CITY OF MADISON
CITY ENGINEERING DIVISION
DEPARTMENT OF PUBLIC WORKS
PLAN OF PROPOSED IMPROVEMENT

N FRANKLIN AVENUE & LYNN TERRACE -
ASSESSMENT DISTRICT 2025
CITY PROJECT NO. 15113
CONTRACT NO. 8766

ADDENDUM 1 - 02/11/25
UPDATED SHEETS: D5-D10,
PD1-PD5, P1-P6, X1-X13

REVISION 1 - 04/03/25
UPDATED SHEETS: COVER,
D6, PD1-PD3, P1-P3, U1-U9,
W1-W9, X3-X11
SHEET ADDED: U10

CITY OF KANSAS SEAL	N FRANKLIN AVENUE PLAN & PROFILE	15113
	N FRANKLIN AVENUE & LYNN TERRACE - ASSESSMENT DISTRICT 2025	MADISON, WI
	M:\DESIGN\Projects\15113\CADStreets\15113EN-PnP.dwg	CONTRACT NO:
		8766
15113	P-1

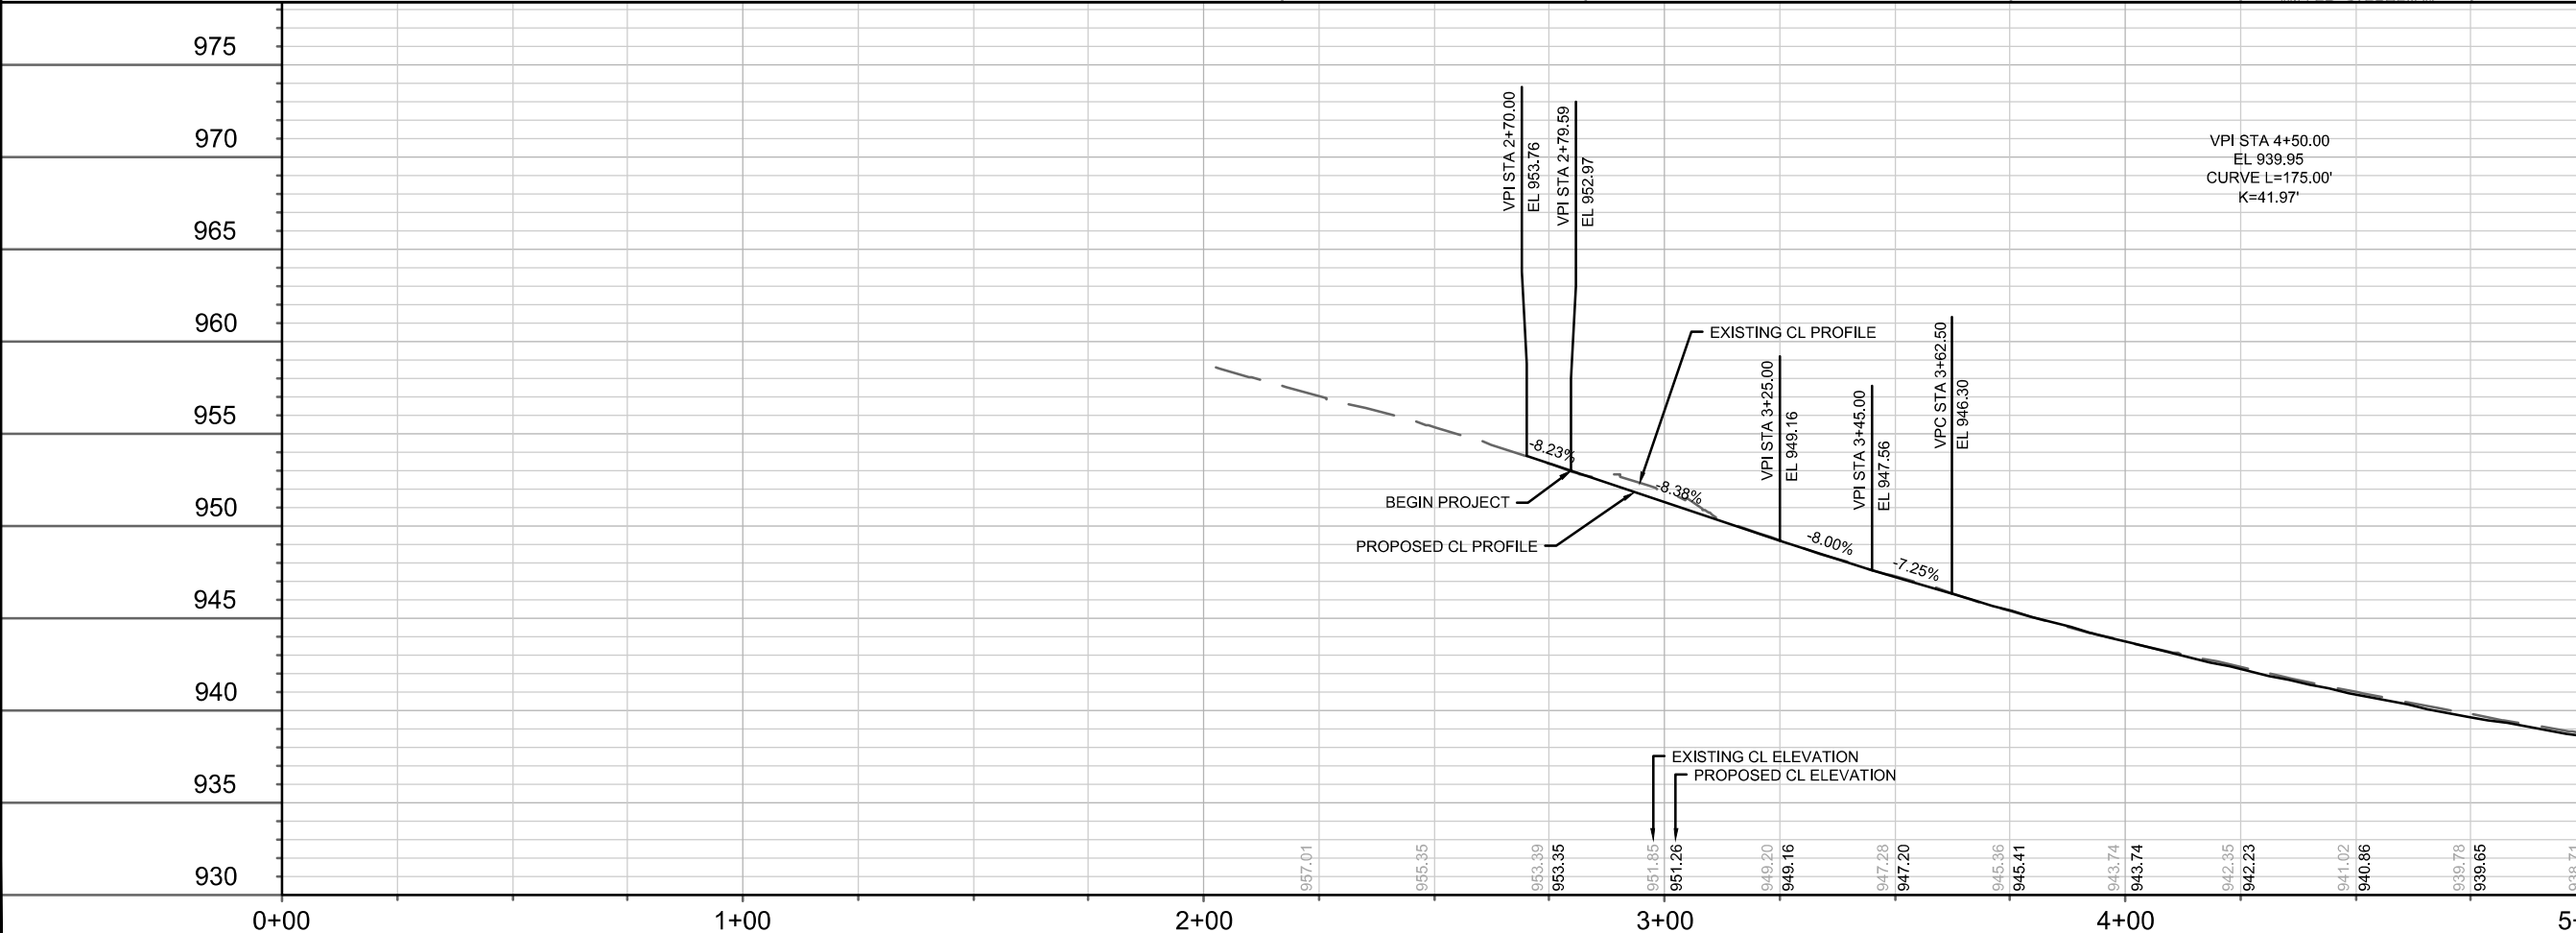
REVISION 1 - GCIT - 04/03/2025
- REPRINTED TO SHOW UPDATED
UNDERGROUND UTILITY LOCATION

P-2

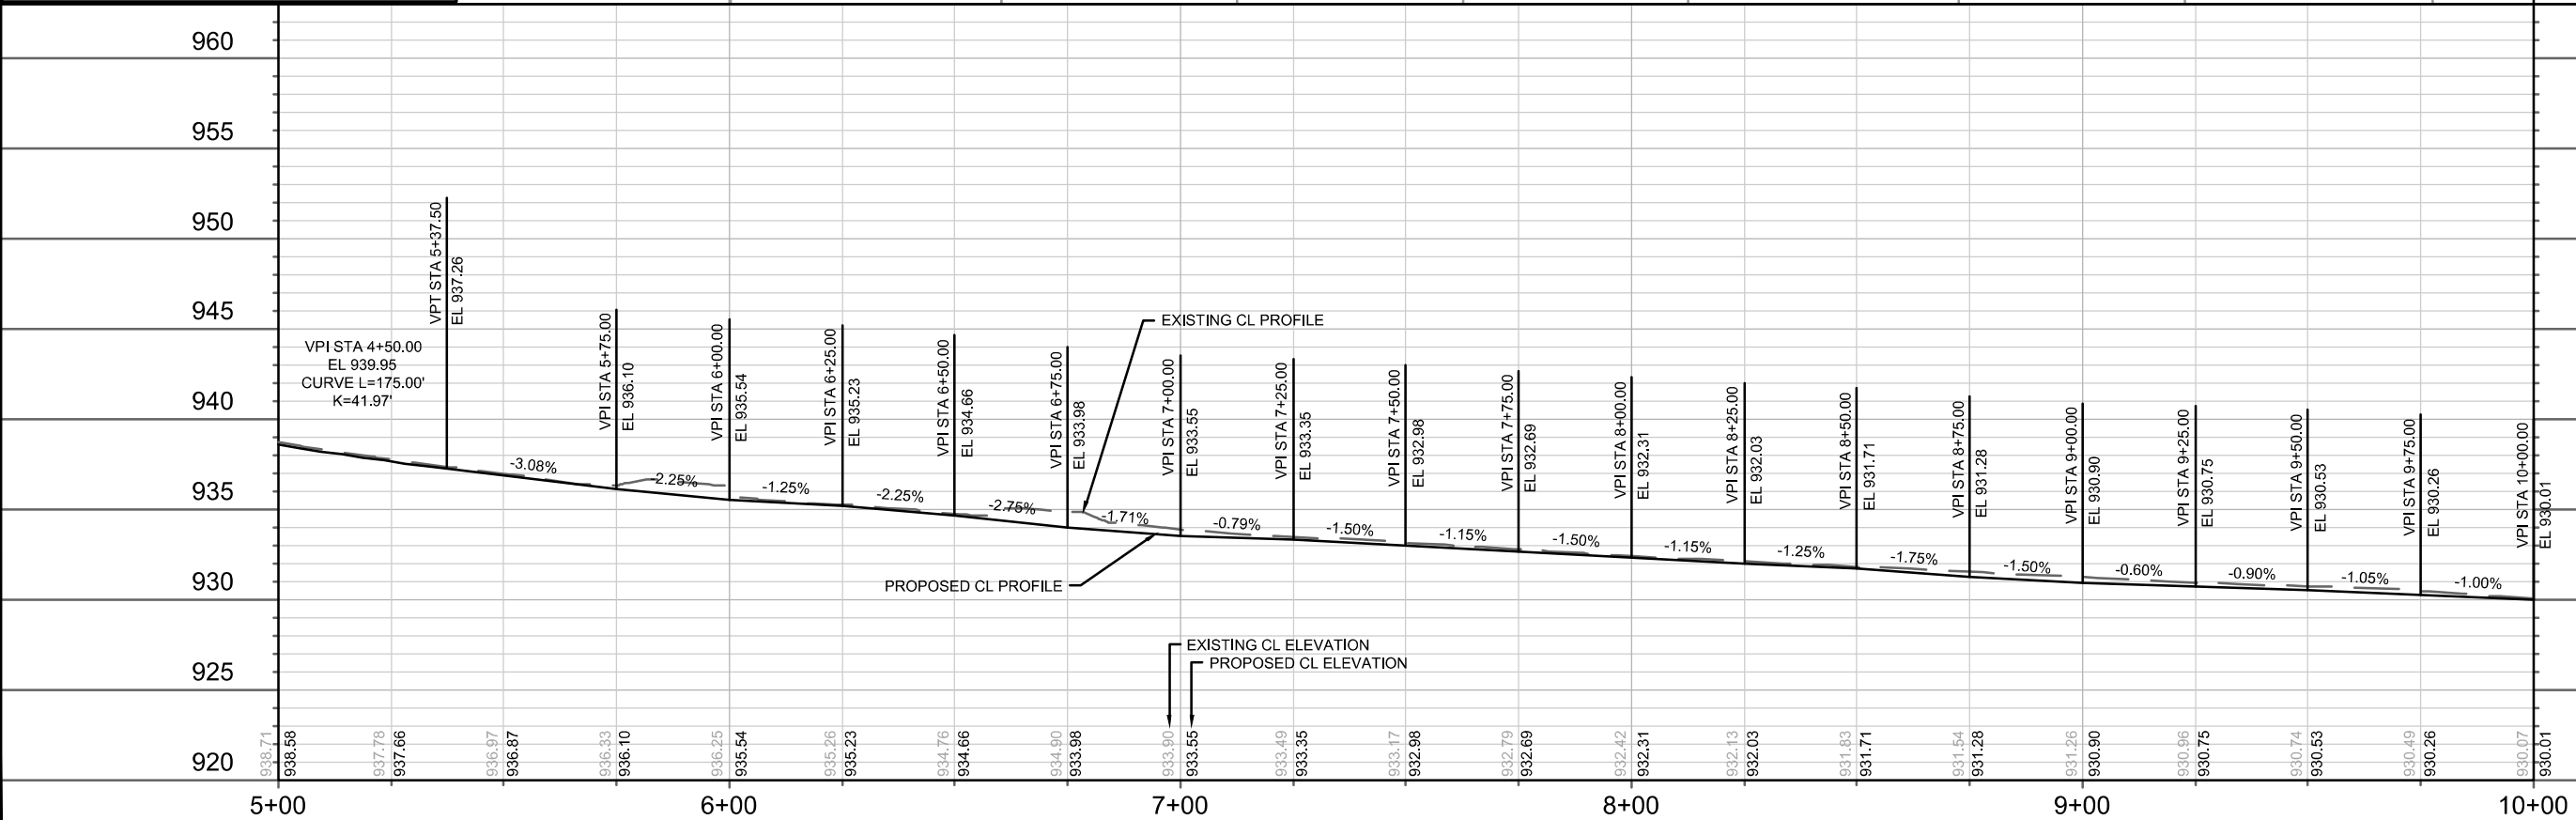
REVISION 1 - GCIT - 04/03/2025
- UPDATED CURB REPLACEMENT LIMITS

15113	MADISON, WI	CONTRACT NO: 8766	P-3
N FRANKLIN AVENUE PLAN & PROFILE			
N FRANKLIN AVENUE & LYNN TERRACE - ASSESSMENT DISTRICT 2025			
M:\DESIGN\Projects\15113\CAD\Streets\15113EN-PnP.dwg			
15113			
P-3

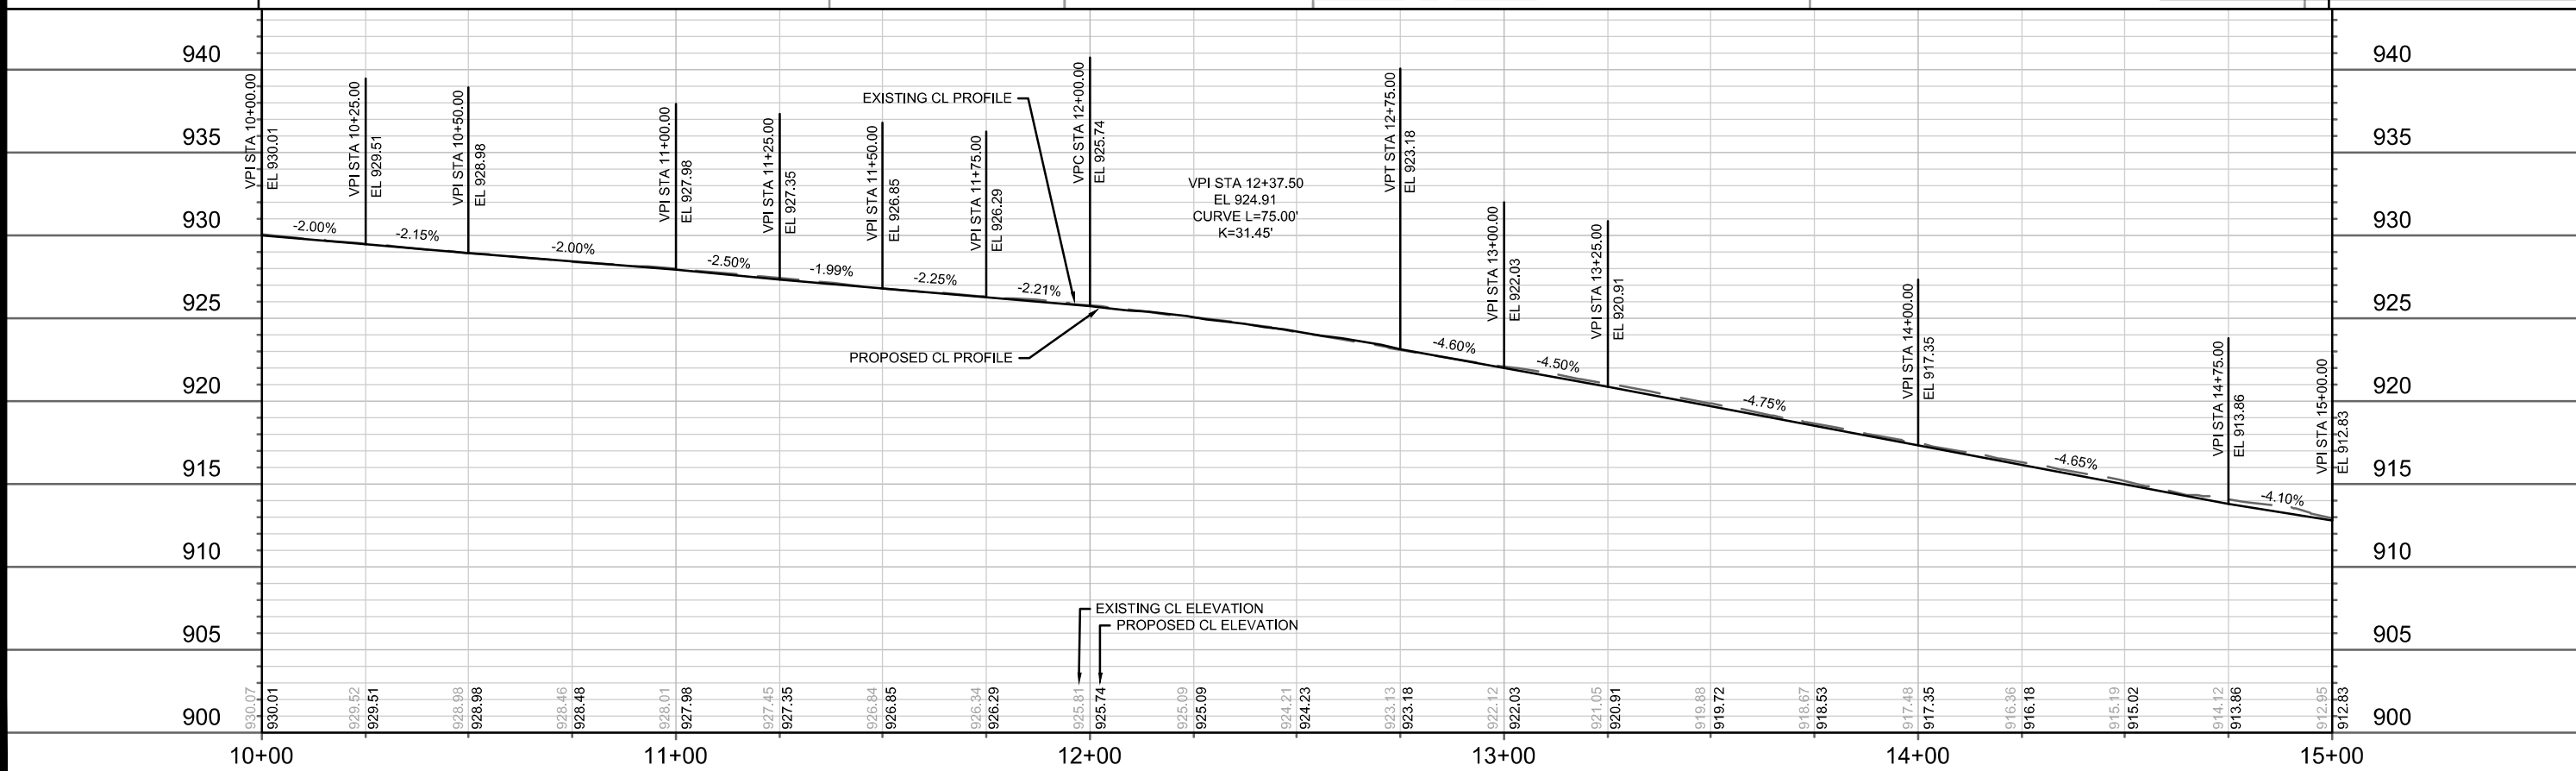
ADDENDUM 1 - GCIT - 02/11/2025
- UPDATED CL PROFILE

REVISION 1 - GCIT - 04/03/2025
- UPDATED CURB REPLACEMENT LIMITS
- ADDITIONAL DWY APRON REPLACEMENT

15113		MADISON, WI		CONTRACT NO: 8766	
N FRANKLIN AVENUE PLAN & PROFILE		N FRANKLIN AVENUE & LYNN TERRACE - ASSESSMENT DISTRICT 2025		M:\DESIGN\Projects\15113\CAD\Streets\15113EN-PnP.dwg	
15113		P-4		15113

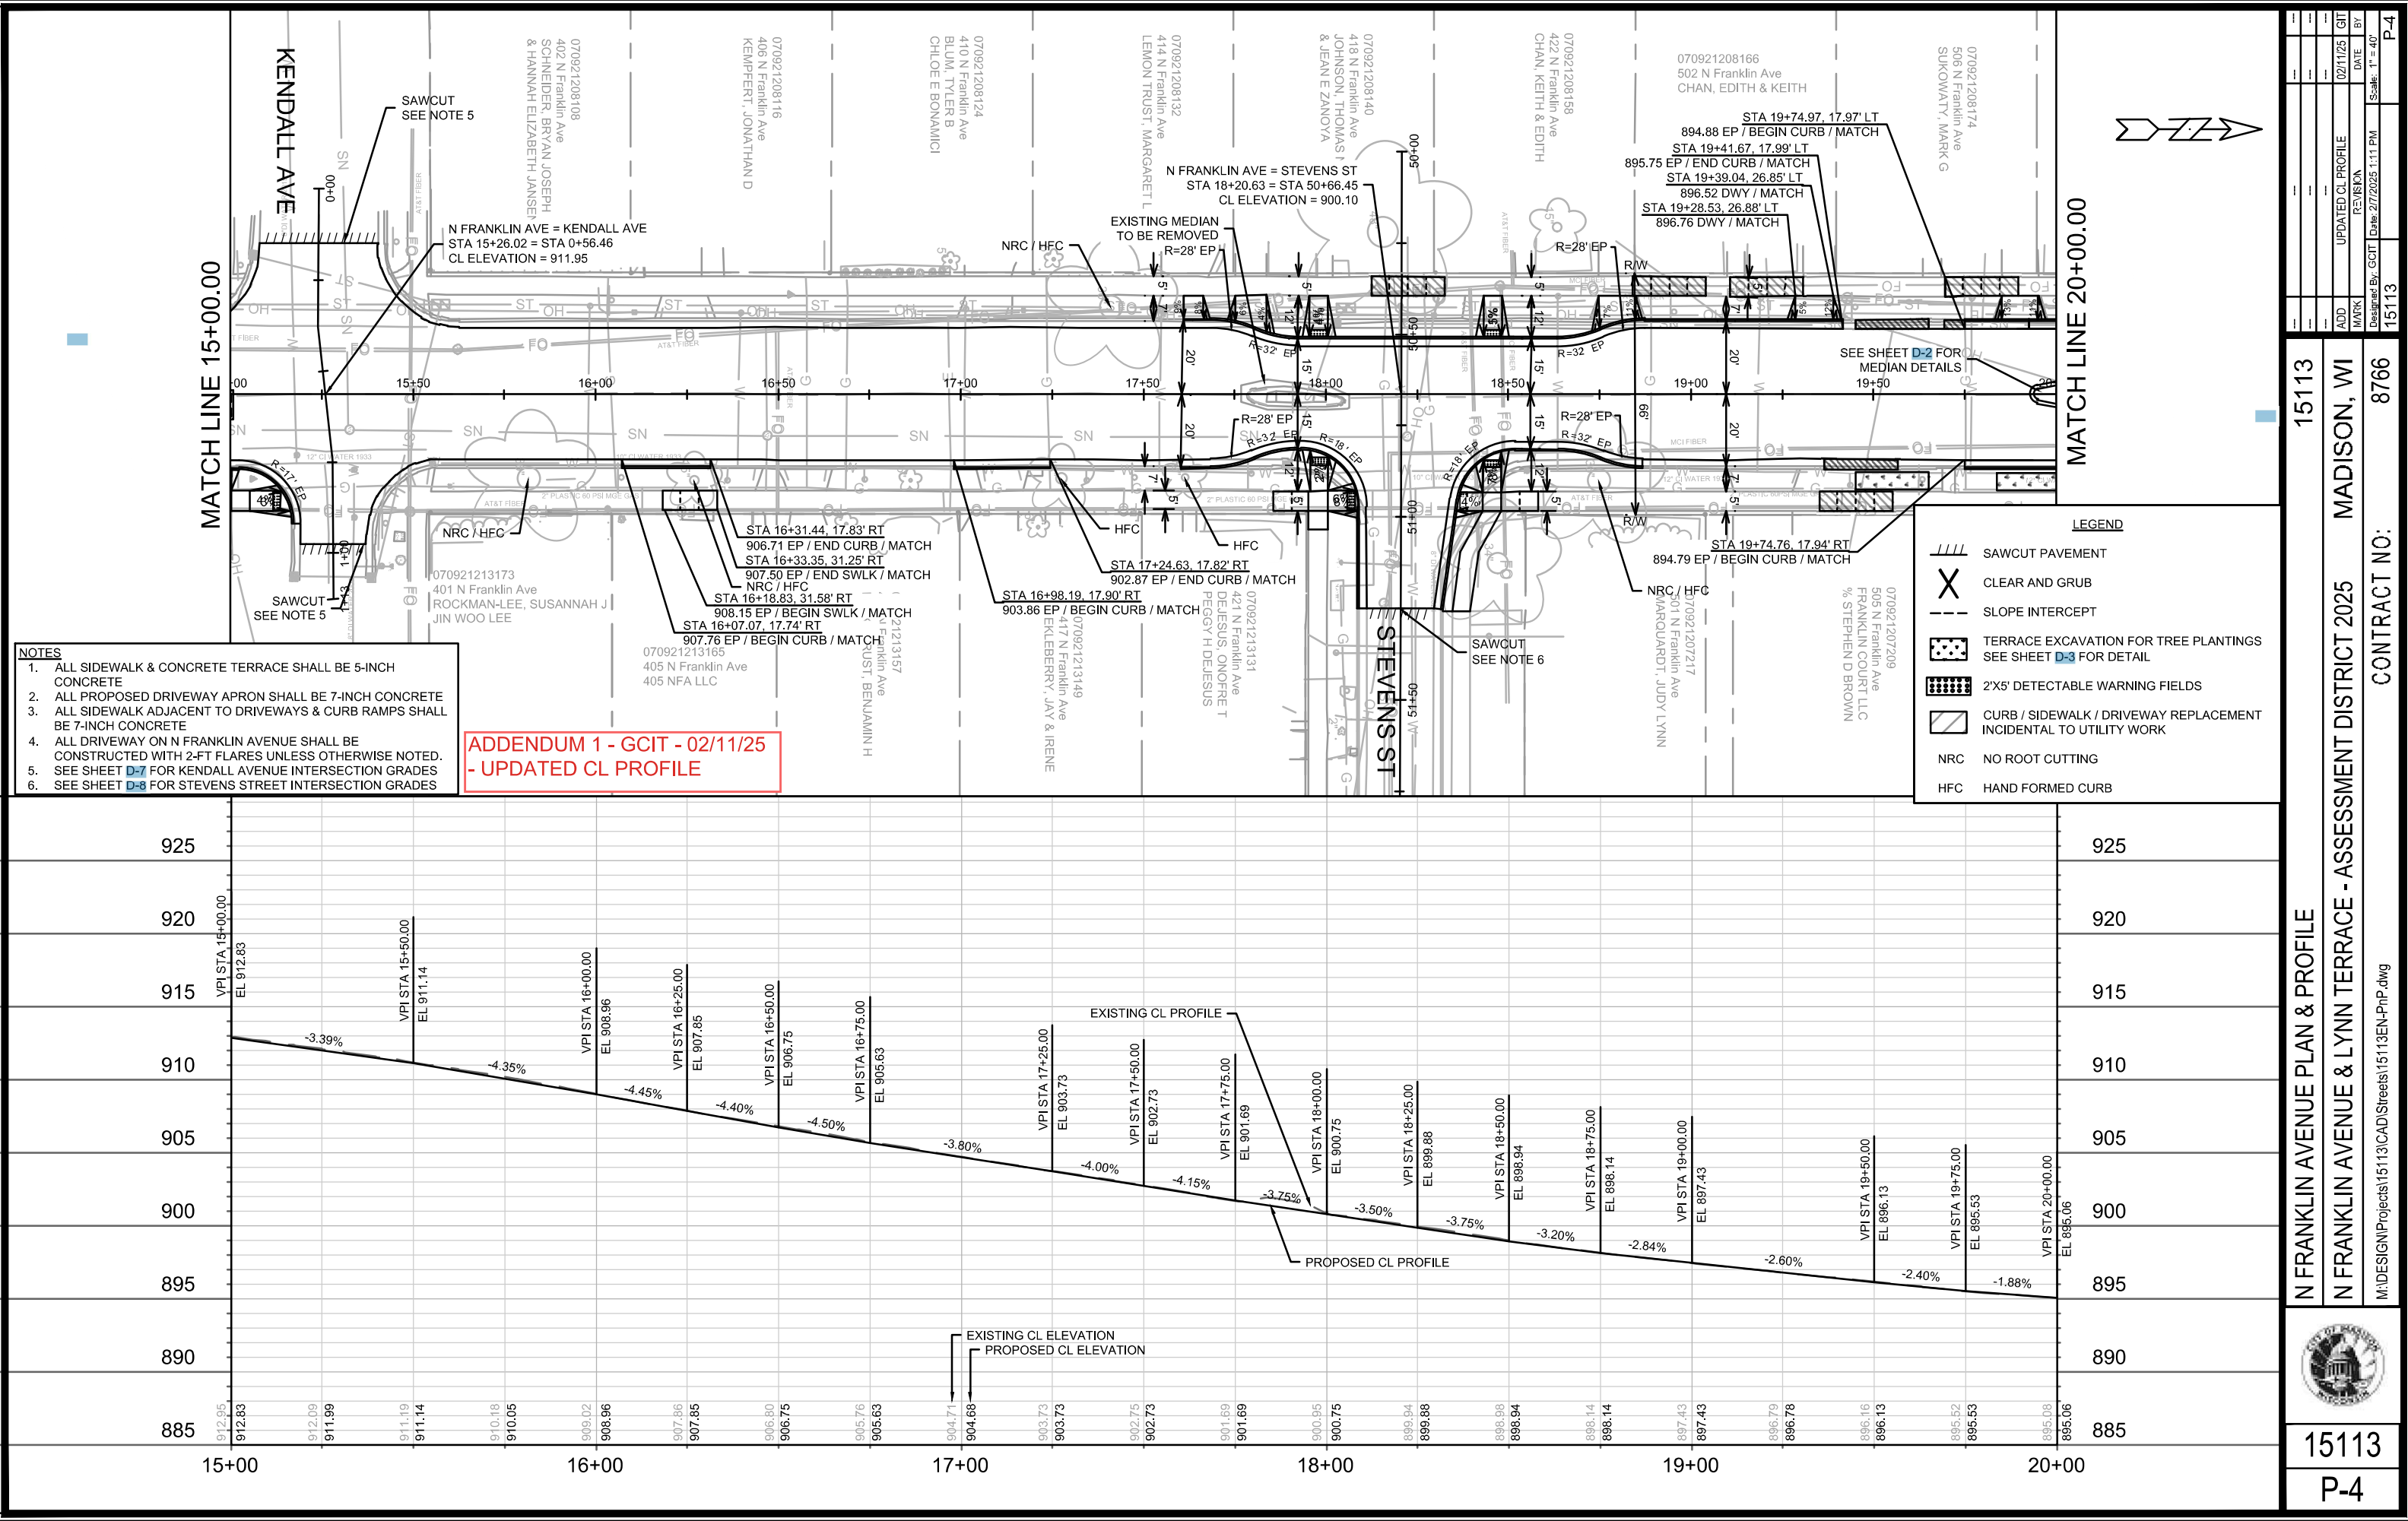
ADDENDUM 1 - GCIT - 02/11/25
- UPDATED CL PROFILE
